Addendum to the Final Environmental Impact Statement - Baffinland Response to Technical Comments November 15, 2013		
Qikiqtani Inuit Association		Baffinland's Response
Number	Recommendation	
Note: See Baffinland Response to Project Certificate 005 Amendment Considerations attached for suggested word changes and new conditions; also see Appendix A,where referenced, for more detailed responses to technical comments.		
FM-01	It is recommended that dust dispersal modeling be revisited to reduce uncertainty and inform monitoring. The quantity and chemical composition of dust entering aquatic systems should be monitored to ensure that mitigation measures are effective. Sediment impact thresholds should be established for Arctic char, and possibly other taxa, to inform impact assessment, monitoring, and mitigation.	<p>Dust dispersion modelling presented in the FEIS was “worst case” as it involved highly conservative assumptions and no dust controls. The FEIS Addendum considered dust controls and other refinements to the model. This is the reason for the reduction in dust deposition despite the overall tonnage increasing with the ERP from 18 to 21.5 Mt/a.</p> <p>Nonetheless, a comprehensiv

Figure 1: Caribou decision tree

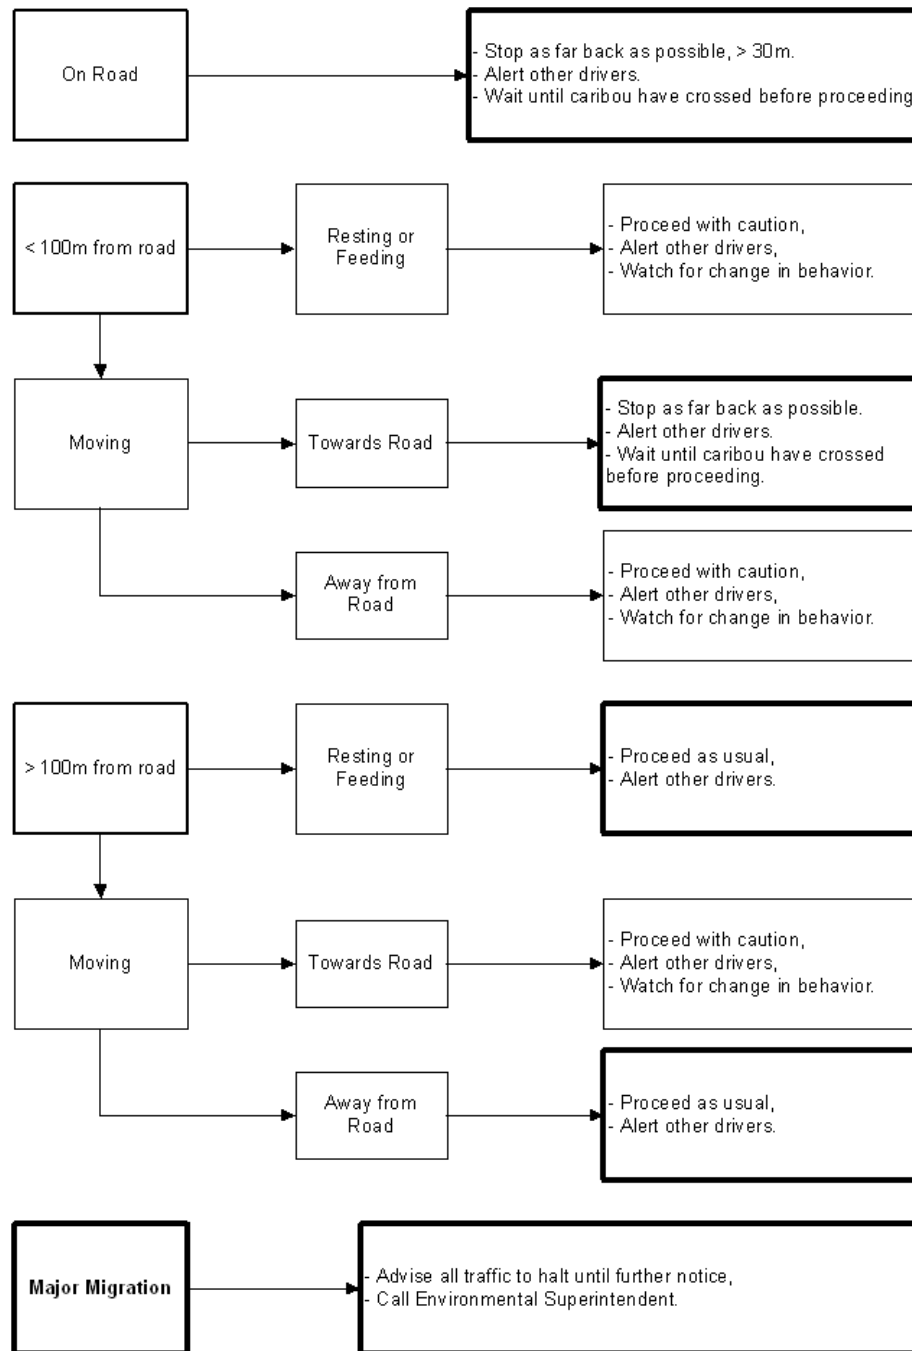
The Proponent must re-evaluate the potential impact on caribou movement of upwards of 200 trucks per day, the majority of them haul trucks, travelling along the Tote Road for the life of the mine. This re-evaluation should include revisions to the mitigation and adaptive monitoring plans and an assessment of residual impacts after mitigation.

The Roads Management Plan should specify how caribou presence on and in the vicinity will be monitored and what thresholds (other than the tracks) will be used to trigger specific levels of traffic management. Baffinland should investigate dash camera technology and wildlife road surveillance systems to prevent collisions and use remote camera monitoring to describe caribou use of the road corridor.

- Modified embankment heights and finer fill material at trails that cross the road (e.g., caribou crossings);
- Snow bank height maintained at less than 1 m;
- Operator radio communication as an early warning of caribou to approaching vehicles;
- Road signage identifying known crossing areas;
- Wildlife right-of-way policy; and
- Implementation of the caribou decision tree (see attachment).

- Snow track surveys along the Milne Inlet Tote Road;
- Monitoring of snow bank heights;
- Check-in/check-out procedure at gates at start and end of Tote Road that includes wildlife reporting;
- Installing cameras at known trail crossings along the road;
- Height of land surveys; and
- On-site wildlife monitor.

QIA's suggestion for dash-mount cameras is not being considered as a monitoring tool. Communication among drivers, check-in at gates for wildlife observations, height-of-land surveys and follow-up investigations of all mortality events are sufficient to monitor and mitigate potential effects on caribou movement.
